Item Name: Fwd Crosstube - Mid Height 206L / L1 / L3 / L4

DART AEROSPACE LTD HAWKESBURY, ONTARIO, CANADA	
DRAWING NO. D206-667-147	REV. A SHEET 1 OF 4
TITLE CROSSTUBE ASS'Y (206L MID FWD)	SCALE NTS
COPYRIGHT © 2010 BY DART AEROSPACE LTD THIS DOCUMENT IS PRIVATE AND CONFIDENTIAL AND IS SUPPLIED ON THE EXPRESS CONDITION THAT IT IS NOT TO BE USED FOR ANY PURPOSE OR COPIED OR REPRODUCED IN ANY OTHER MANNER WITHOUT WRITTEN PERMISSION FROM DART AEROSPACE LTD.

DRAWING NO. D206-667-147	TITLE CROSSTUBE ASS'Y (206L MID FWD)	REV. A	DART AEROSPACE LTD ENGINEERING ORDER		D.E.O. NO. D206-667-147-A-1	SHEET NO. SHEET 1 OF 1	SCALE NTS
DRAWN <i>q</i>	CHECKED <i>ASS</i>	MFG. APPR. <i>JB</i>	APPROVED <i>MD</i>		DE APPR. <i>MD</i>		
DATE 11.07.15	DATE 11.07.20	DATE 11.07.21	DATE 11/07/21		DATE 11.07.21

DRAWING NO. D206-667-147	TITLE CROSSTUBE ASS'Y (206L MID FWD)	REV. A	DART AEROSPACE LTD ENGINEERING ORDER	D.E.O. NO. D206-667-147-A-2	SHEET NO. SHEET 1 OF 1	SCALE NTS
DRAWN AJS	CHECKED	MFG. APPR.	APPROVED	DE APPR.		
DATE 12.08.02	DATE 12.08.02	DATE 12.08.02	DATE 12.08.02	DATE 12.08.02

DETAIL P
BONDING STRAP INSTALLATION 2 PL

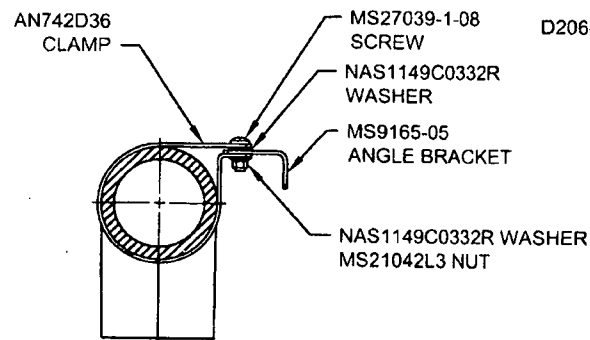
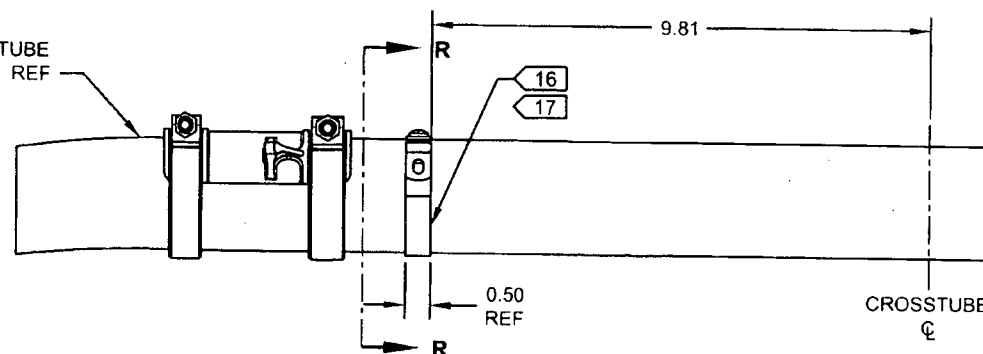
ADD ELECTRICAL GROUNDING STRAP
